### Substantive: Fairway Estates Phase II PUD/Subdivision Application

Date: February 3, 2023  
To: City of Florence, Planning Department  
From: Metro Planning, Inc.  
Subject: Substantive Comments for PC 21 39 SUB 03 & PC 21 40 PUD 02

Agency File No.: PC 21 39 SUB 03 & PC 21 40 PUD 02  
Agency Contact: Wendy Farley Campbell, Planning Director, AICP  
Determination: March 25, 2022  
1<sup>st</sup> 120 Day Rule Waiver: **January 4, 2023**  
2<sup>nd</sup> 120 Day Rule Waiver: **May 4, 2023**

Subdivision Name: Fairway Estates Phase 2  
Map/Lot: 18-12-15-00, TL 1500  
Site Address: Florence Oregon 97439

A - Alt 1 and Alt 2 above from Oregon Fire Code: Alternatives - Hammerhead Emergency Turnaround

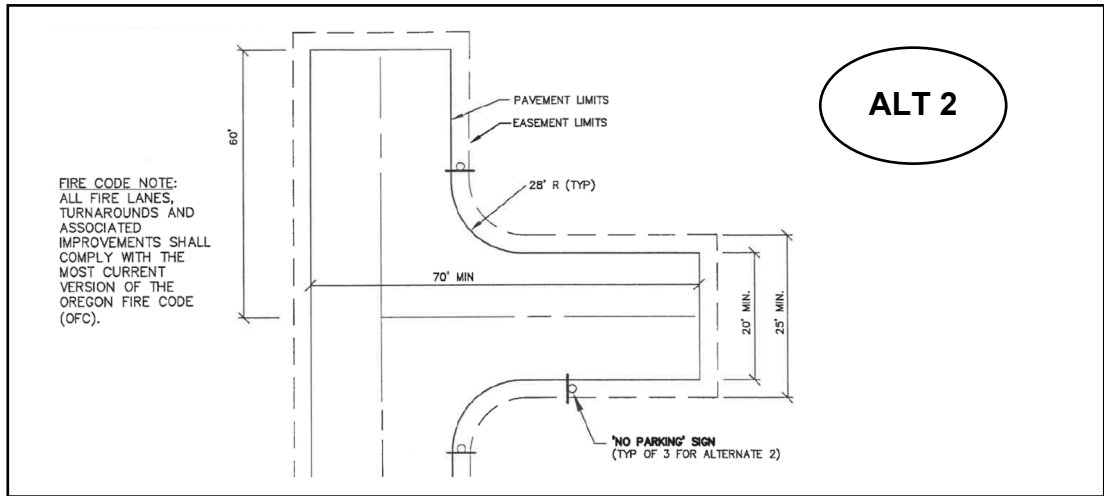
1. Will the entire road through the planned development be completed or is the plan just to complete the road to the end of the Phase II development resulting in a dead end? If the road doesn't go all the way through we will require a turnaround. Road width is adequate. (He also provided D103.1 and D103.4 referenced below)<sup>1</sup>

Response: Any required phased development will comply with Florence City Code (FCC) and Oregon Fire Code (OFC) to support an emergency turnaround. Please see diagram below for proposed alternatives for dead-end turnaround for emergency access compliance.

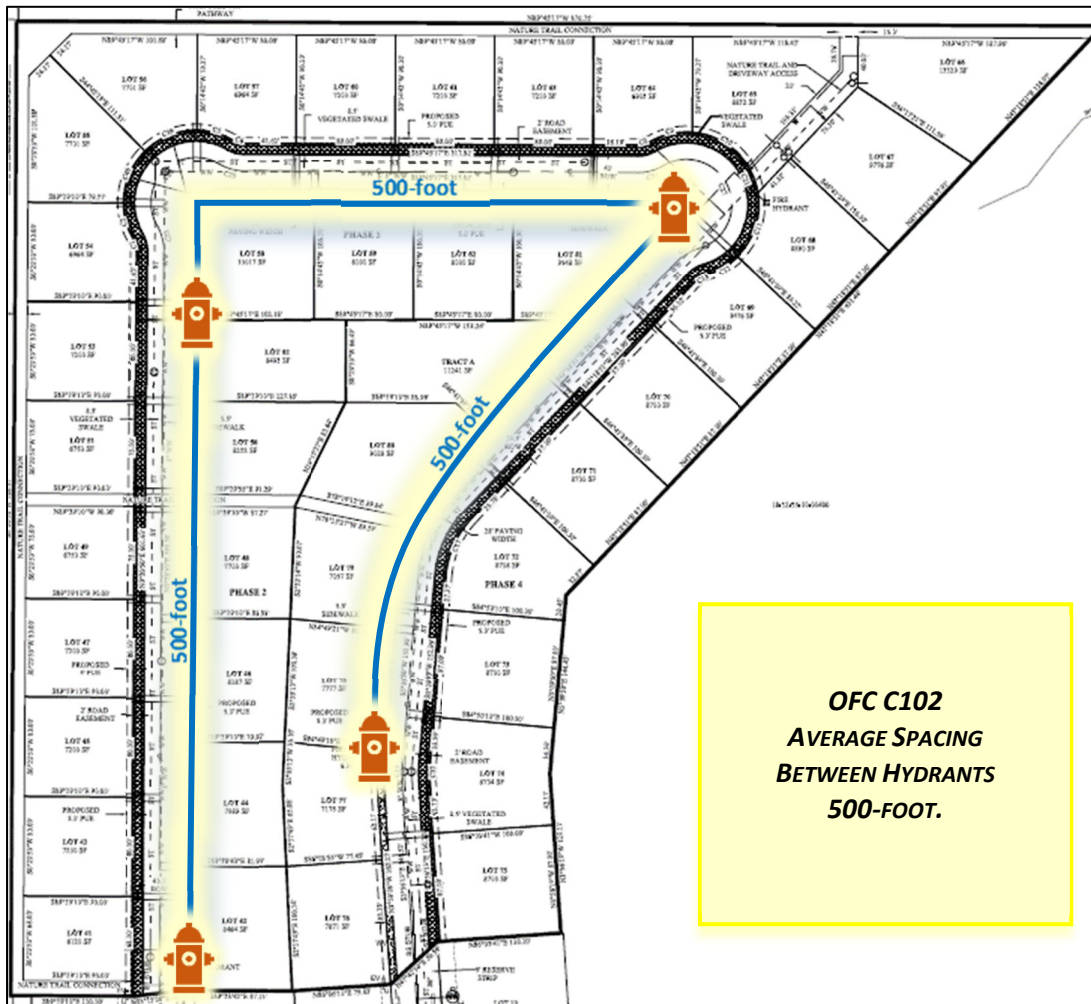
**Hydrant locations on Proposed Utility Plan will need to be updated. Current indicated locations will not provide an average spacing of 500 feet between hydrants and 250' from any point on the street to a structure. It looks like they may not have taken into account hydrants actually placed in the Phase I development.<sup>2</sup>**

Response: Please see revised utility plans with hydrant locations, every 500-foot, and compliance with OCF Section C102.<sup>3</sup> Applicant is willing to loop the water main and add additional hydrants to help address issues raised below about secondary access.

Map 1 – Original Sandpines Master Plan Submittal (Planned Unit Development) November 2003<sup>11</sup>

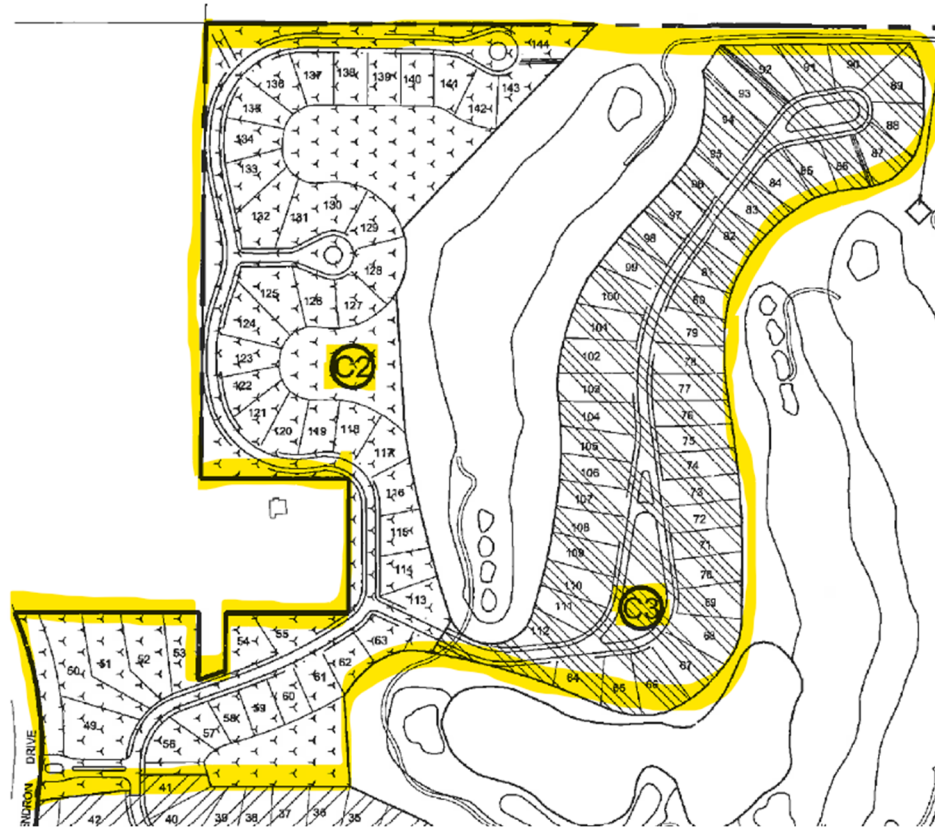
**... My recommendation is that all new homes have automatic sprinklers installed or a second access road on the north end of the development is put in place. This is all dependent on what Tony and the city agreed to previously.**

2. Applicant is proposing nearly the same number of buildable lots that were approved for development in the original PUD in areas north of the intersection with Rhododendron Drive. Under the original Sandpines PUD, these areas included 80 lots. With the current proposal and the existing approved lots in these areas, total count will be 81 lots. Please see maps below that highlight these areas on original PUD.

3. APIC FLORENCE HOLDINGS LLC owns areas identified as C3, in the map below, and the adjacent golf course property. Should additional access to the east be required, both motive and ability would fall within the control of the golf course property owner, not the current owners of the site being proposed herein. Burdening the current owner/applicant is neither warranted nor achievable. Therefore, introducing and adhering to this standard now would not achieve the purpose of this regulation as applicant does not own properties where secondary access could be constructed.
